Individual Executive Member Decision

Title of Report:	Falmouth Way Traffic Calming
Report to be considered by:	Individual Executive Member Decision
Date on which Decision is to be taken:	06/01/2011
Forward Plan Ref:	ID2189

Purpose of Report: To consider an objection to a proposed traffic calming feature on Falmouth Way, Thatcham.

Traffic Calming - Falmouth Way, Thatcham

81484 - 001

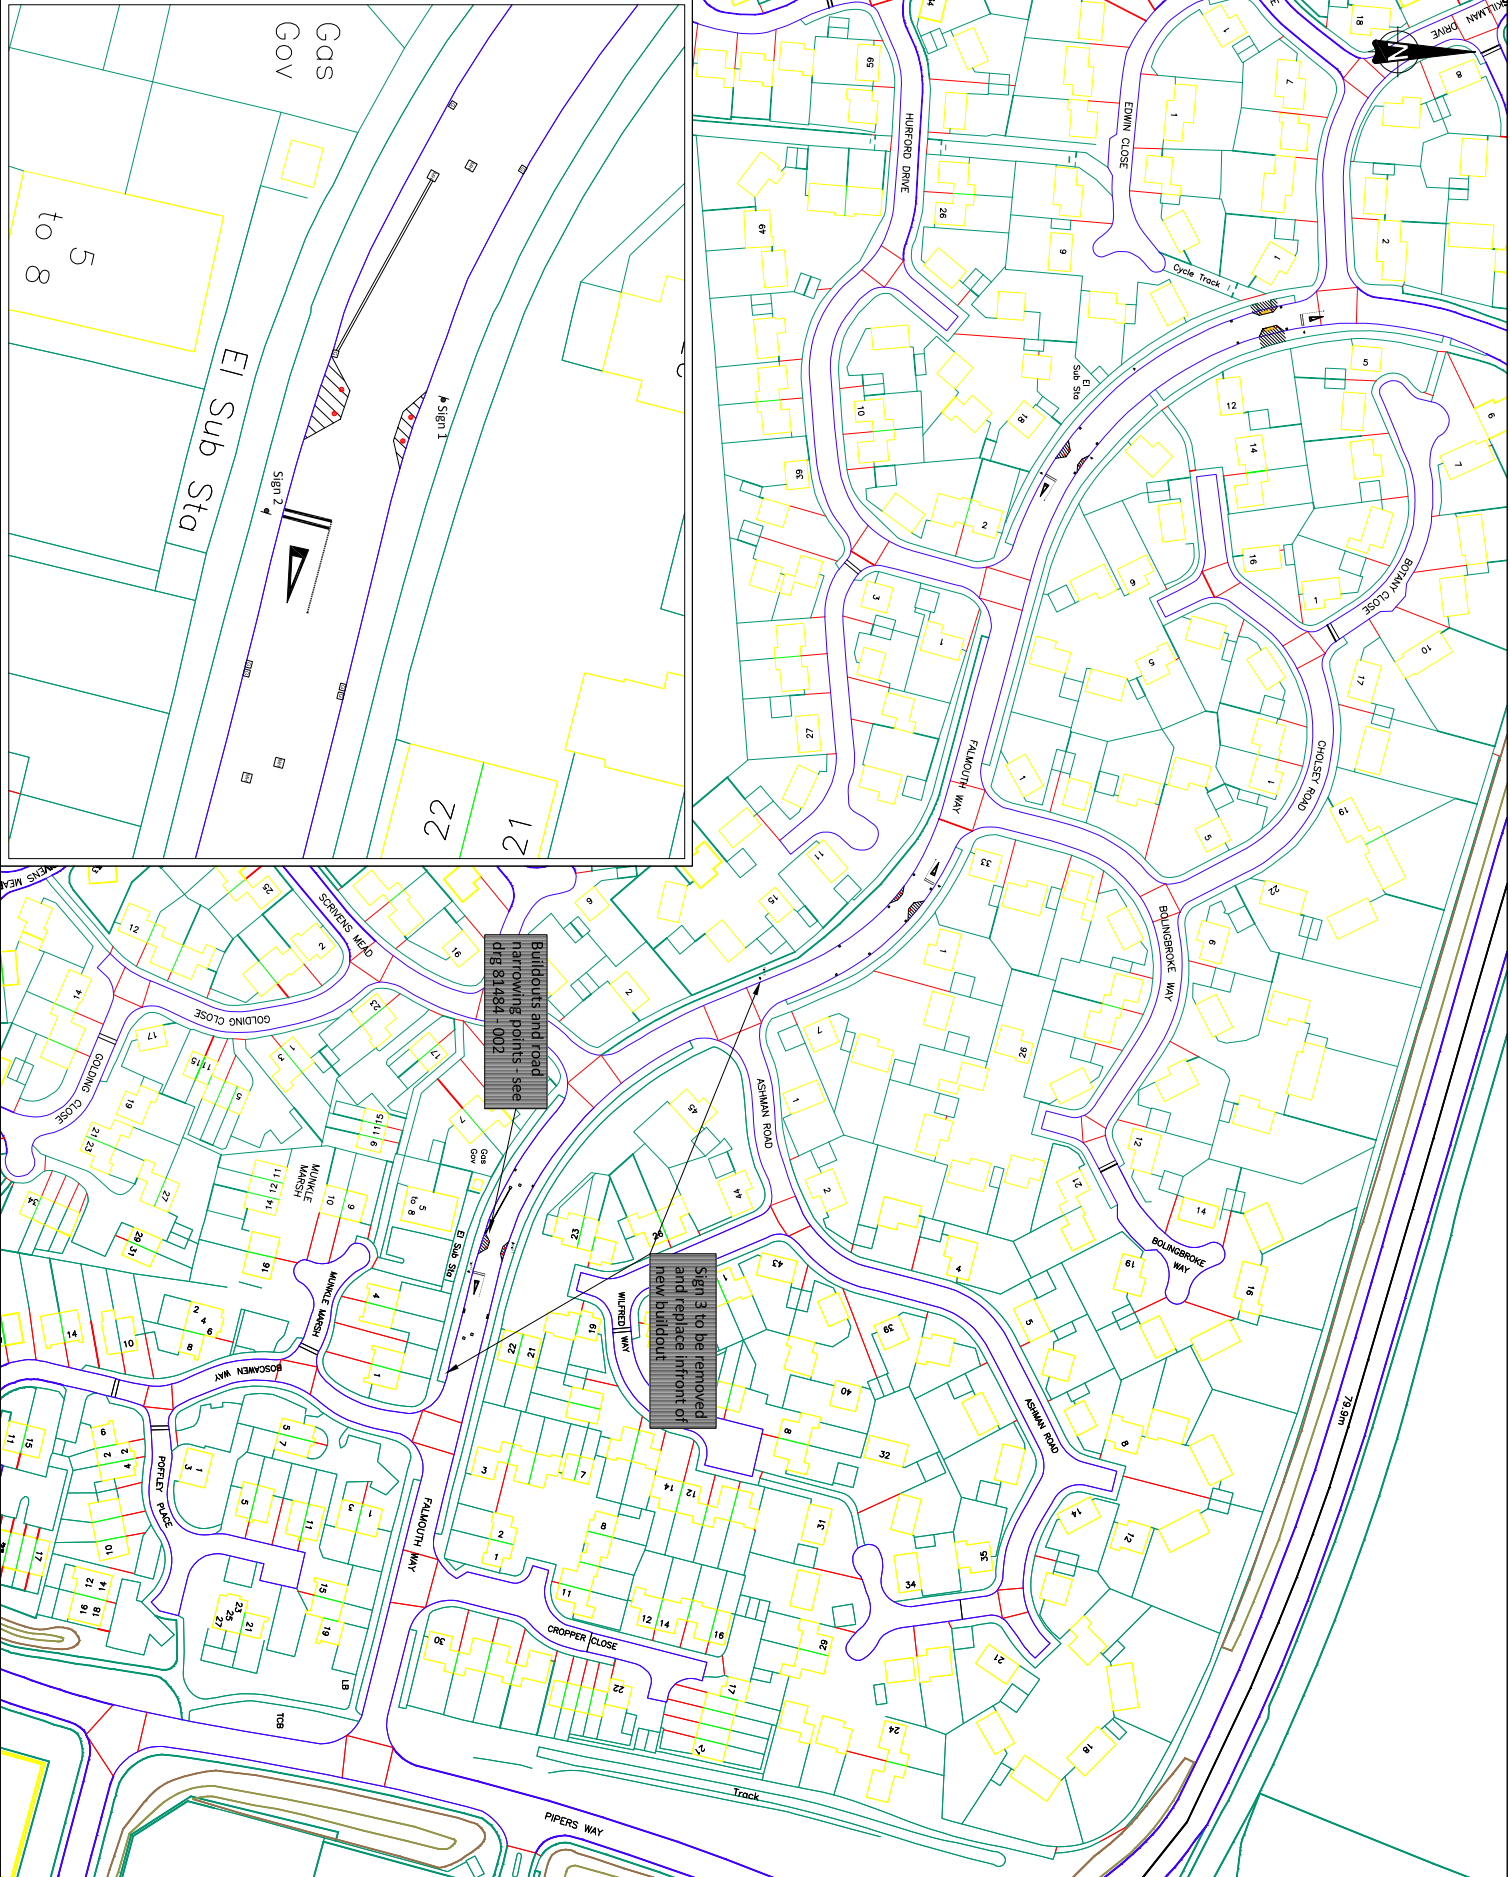
- 2.1 The ward members were consulted on the proposals in July 2010 and both were supportive. In September 2010, local residents in the immediate vicinity of the proposed road narrowing and Thatcham Town Council were consulted. No objections were received from the residents but Thatcham Town Council objected as they considered that there was a “lack of supporting evidence justifying the expenditure or impact on kerbside parking issues at the eastern end of Falmouth Way”. The full letter is included in Appendix B.
- 2.2 Further information was provided to the Town Council in response to their letter to explain the background of the project and to clarify that any impact on parking on Falmouth Way could be investigated and managed once the project was implemented. However, the Town Council did not feel able to withdraw its objection.

The Members resolved that objection be raised to the proposed 'build out' given the lack of supporting evidence justifying the proposed expenditure or impact on kerbside parking issues at the eastern end of Falmouth Way.

- 3.1 A vehicle speed survey was undertaken between 14th and 18th October 2010 on Falmouth Way to the east of its junction with Scrivens Mead, close to the location of the proposed narrowing. The 85th percentile speeds for eastbound and westbound traffic were 34 and 31 mph respectively. The corresponding average (mean) speeds were 28.8 and 26.5 mph. 34 per cent of eastbound vehicles and 15 per cent of westbound vehicles exceeded the 30mph speed limit.

- 3.2 The above survey results are not considered to indicate a severe speeding problem, but as the proposed traffic calming feature is intended to complement an existing scheme it is considered that it would assist in the control of vehicle speeds. Because the road is narrowed to both sides, the calming feature should reduce speeds in both directions, not just the vehicles which have to give way. It would also assist in deterring traffic from using Falmouth Way as a “rat-run” and encourage drivers to use the A4 and Pipers Way, the main distributor roads in the area.

3.3 Parking problems associated with vehicles visiting the S.S.E. site have been observed on Falmouth Way close to its junction with Pipers Way. However, a series of restrictions has been introduced by the Traffic and Road Safety team to remove parked vehicles from potentially dangerous locations and address the concerns of local residents. It is considered that any further problems with parked vehicles could be addressed after the construction of the narrowing. It should be noted that the vast majority of vehicles which have been parked on Falmouth Way have been linked to the S.S.E. site and not owned by local residents. Residual parking issues in the area could be resolved by dialogue with S.S.E.

- 4.1 In view of the above, and recognising that this project was initiated by a request from the local ward member, it is recommended that the traffic calming feature should be constructed as planned.
- 4.2 In response to the concerns raised by Thatcham Town Council, it is further recommended that on-street parking on Falmouth Way be monitored following completion of the project and appropriate measures taken as necessary.
